ADDENDUM

NO. 1

PROJECT NAME: Early Learner's Academy 2

ADDENDUM DATE: June 19, 2025

1 ROOF PLAN
1/16" = 1'-0"

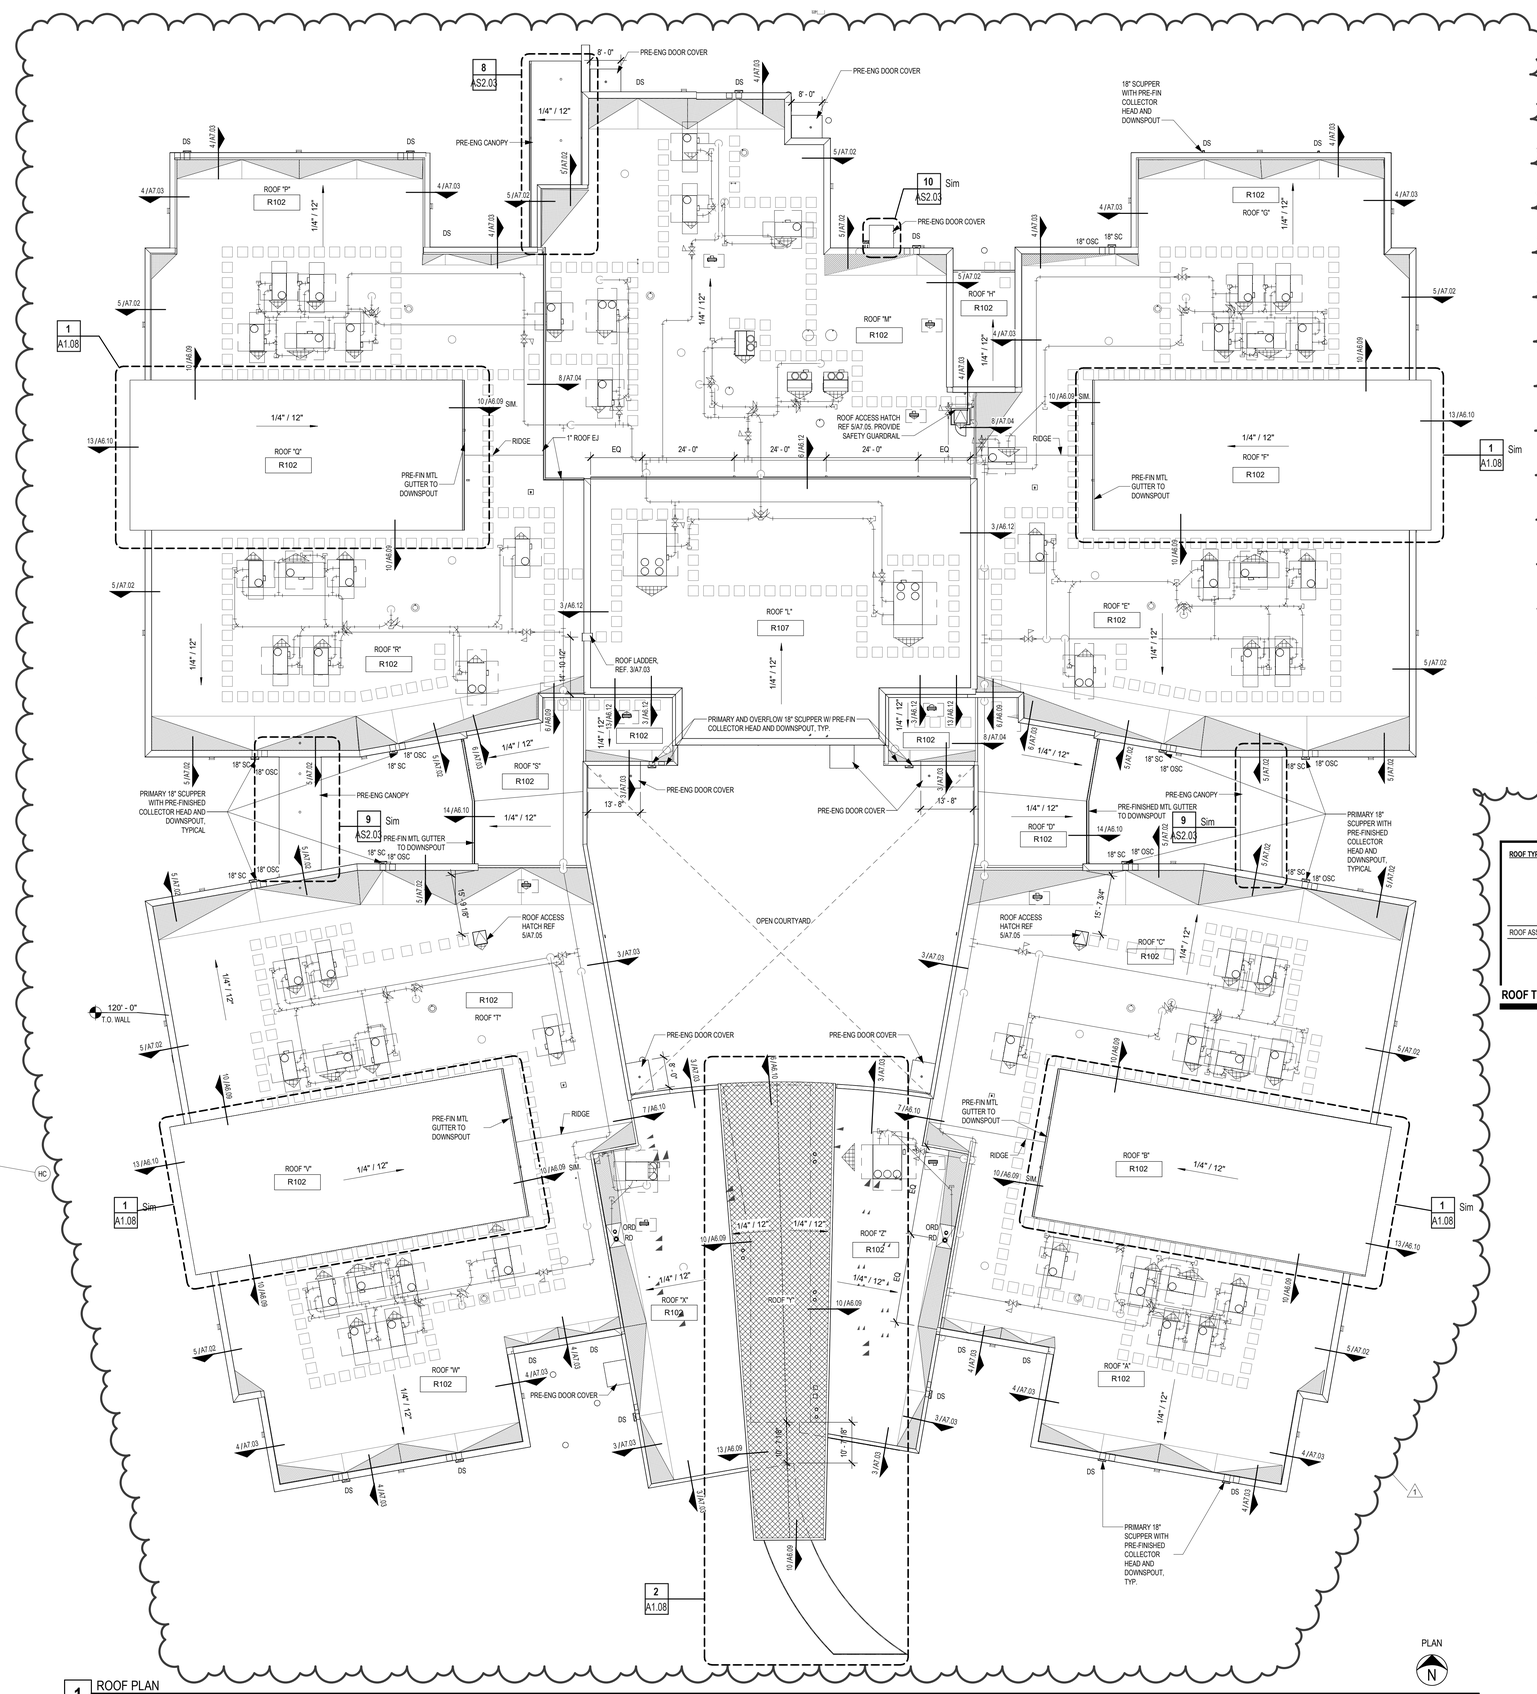
AD No 1, Arch. Item 27: To the Drawings, Sheet A7.01, "ROOF PLAN,"
For clarification, parapet callouts added.

1 POWER PLAN - AREA C
1/8" = 1'-0"

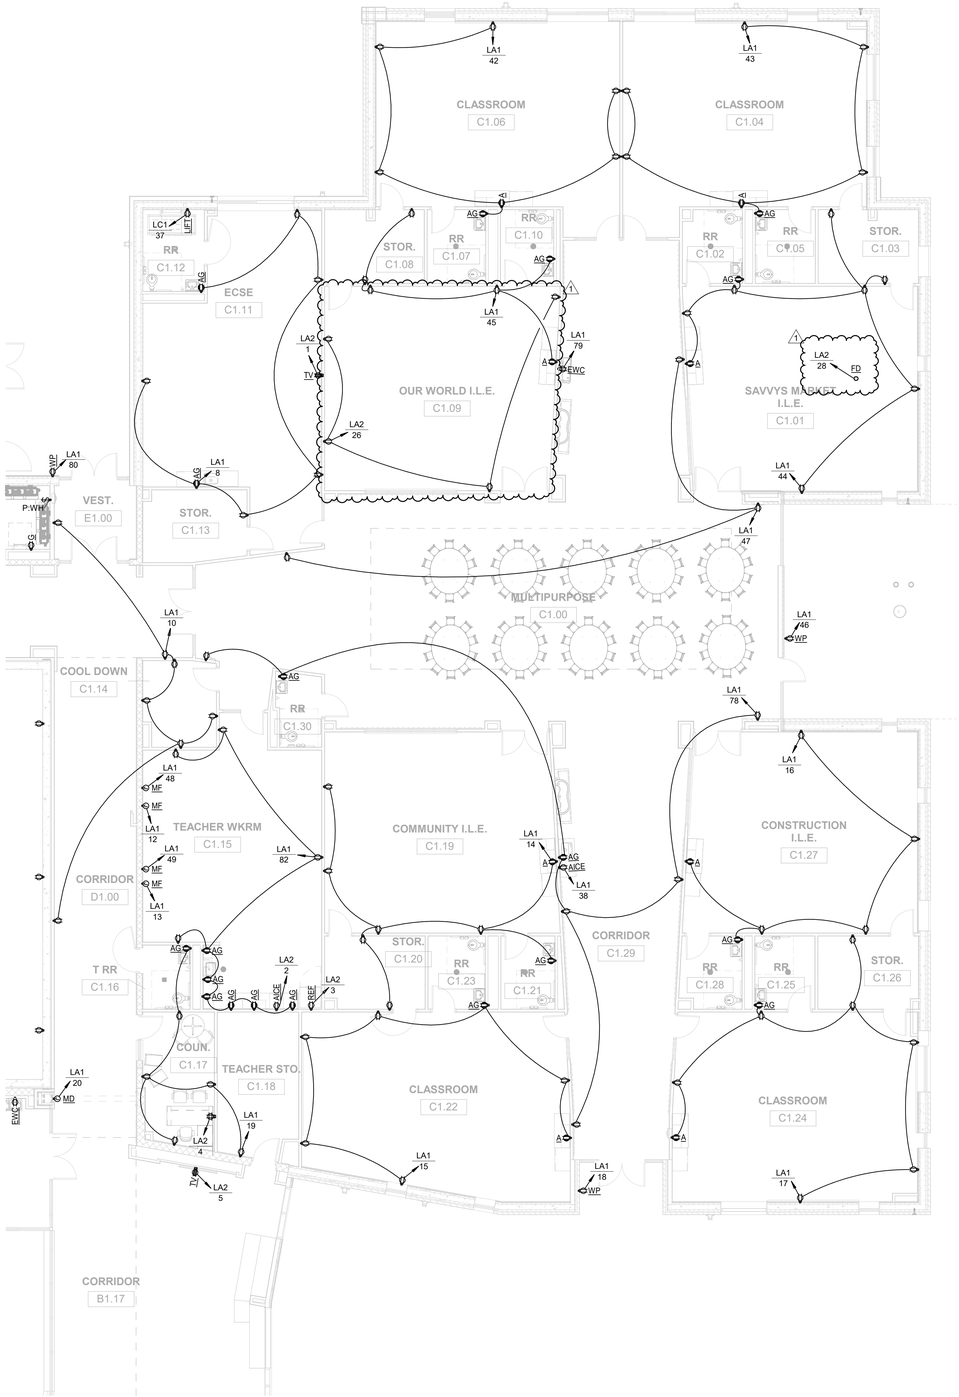
AD No 1, Elec. Item 2: To the Drawings, Sheet E2.03, "POWER PLAN – AREA C,"

1) Revised outlet locations and circuiting based on classroom exhibits for rooms C1.09.
2) Added floor mounted duplex and note for classroom exhibit in room C1.01.

1 POWER PLAN - AREA F
1/8" = 1'-0"

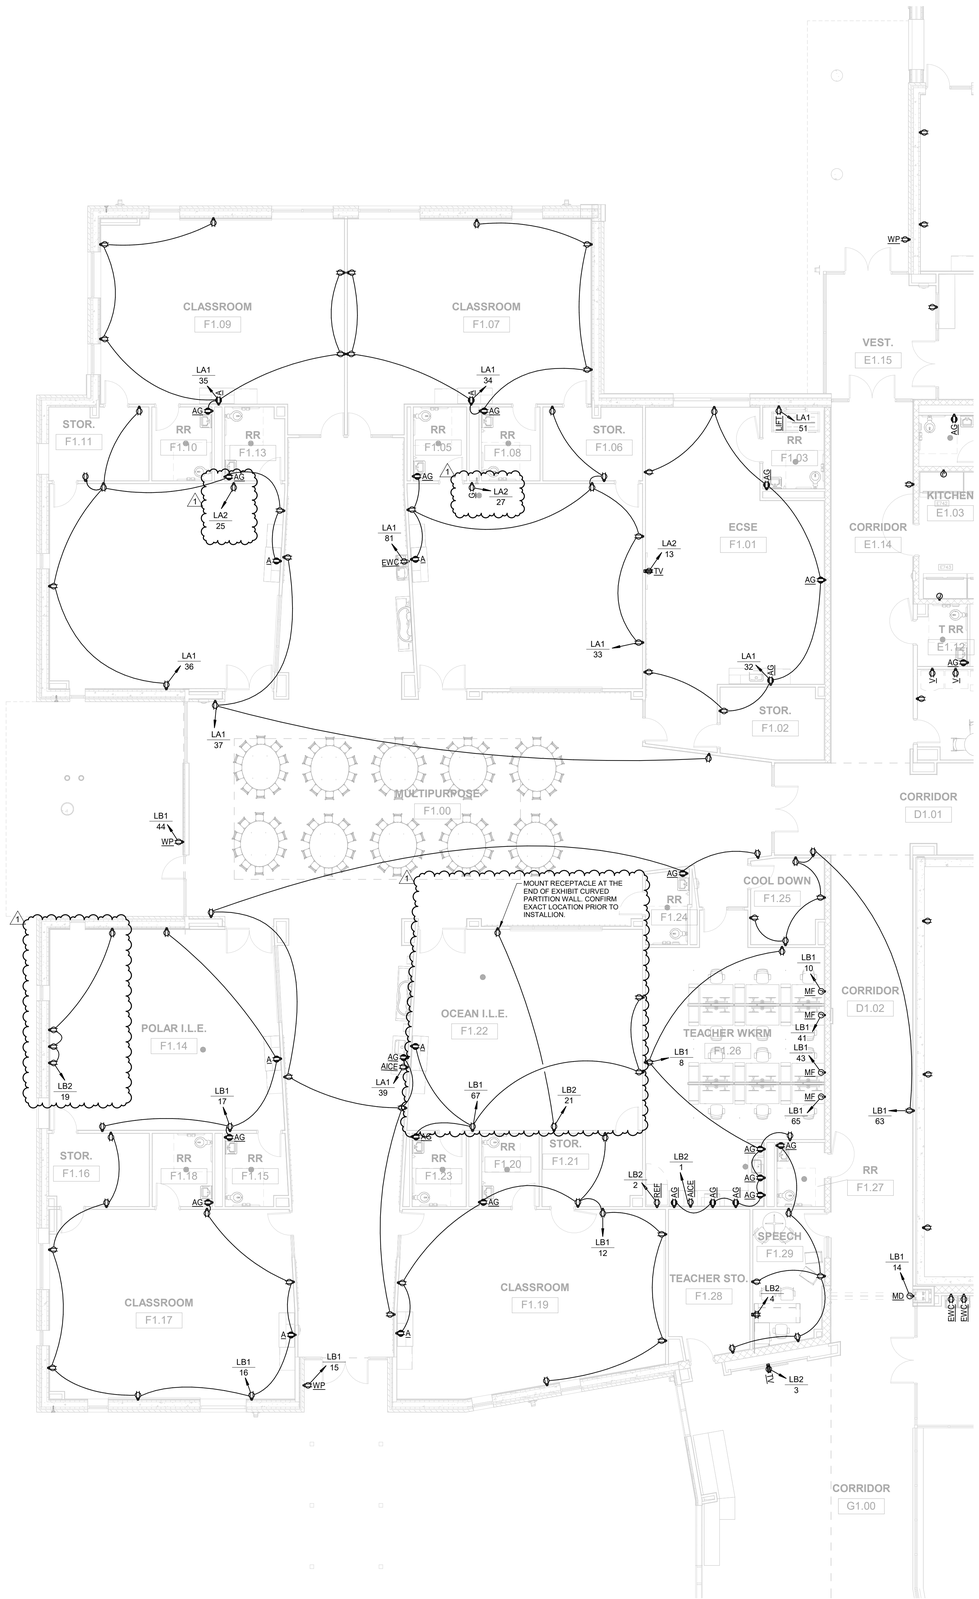
AD No 1, Elec. Item 4: To the Drawings, Sheet E2.06, "POWER PLAN – AREA F,"

1) Revised outlet locations and circuiting based on classroom exhibits for rooms F1.04, F1.12, F1.14, & F1.22.

1 POWER PLAN - AREA G
1/8" = 1'-0"

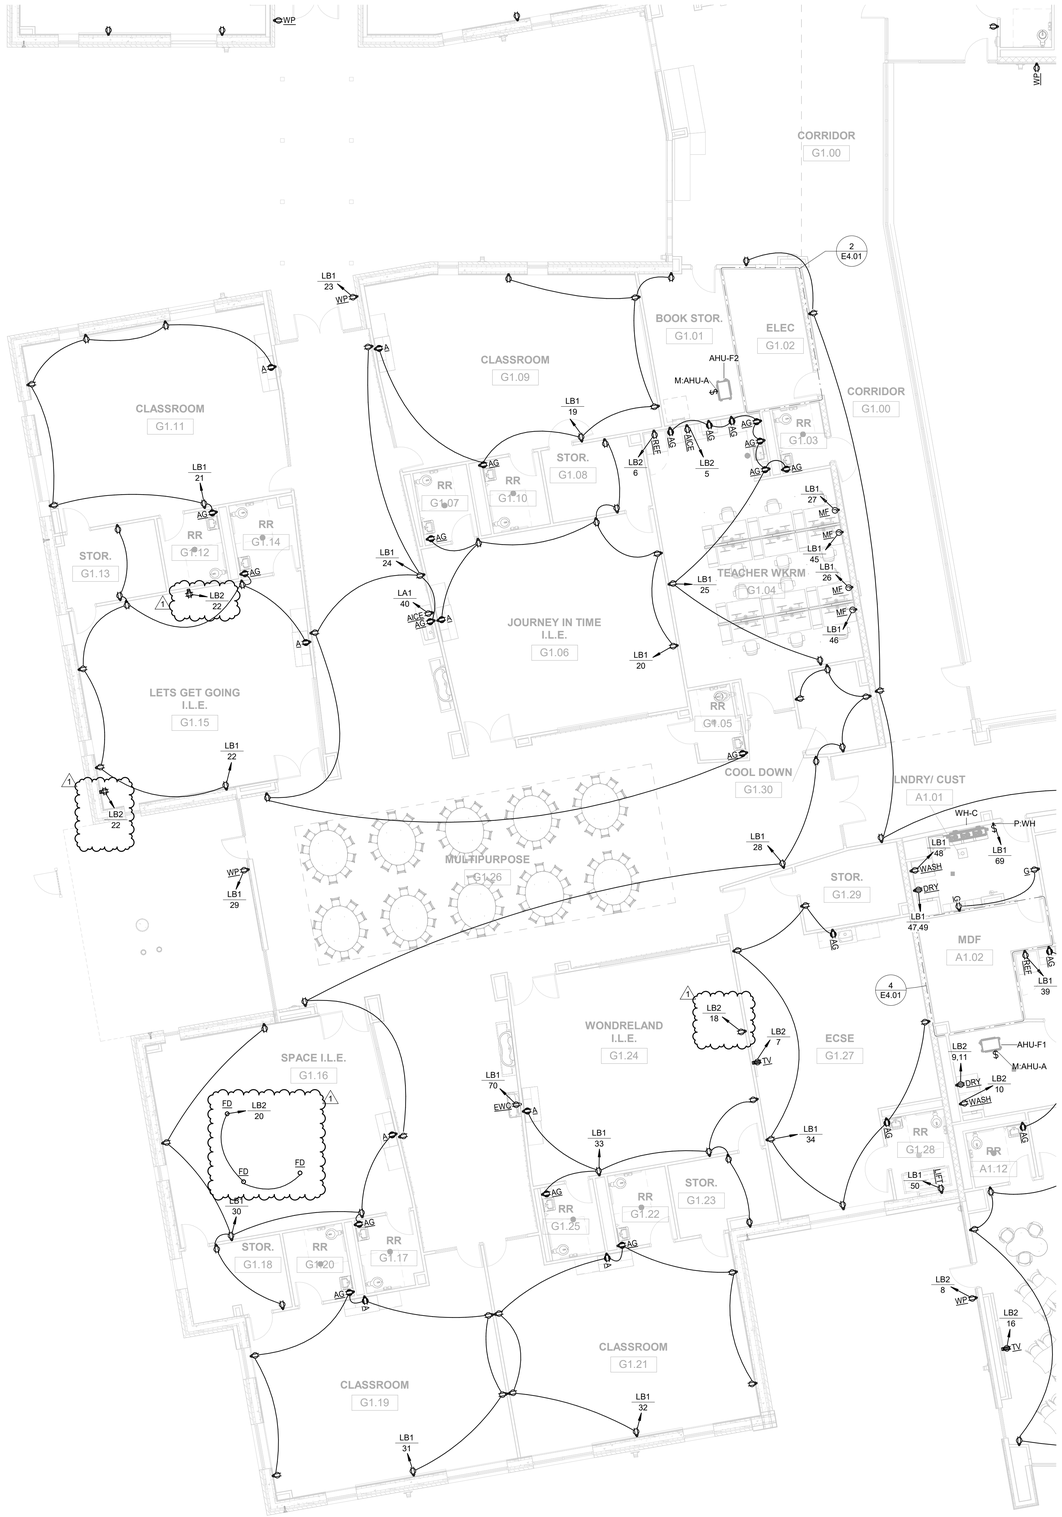
AD No 1, Elec. Item 5: To the Drawings, Sheet E2.07, "POWER PLAN – AREA G,"

1) Revised outlet locations and circuiting based on classroom exhibits for rooms G1.15, G1.16, & G1.24
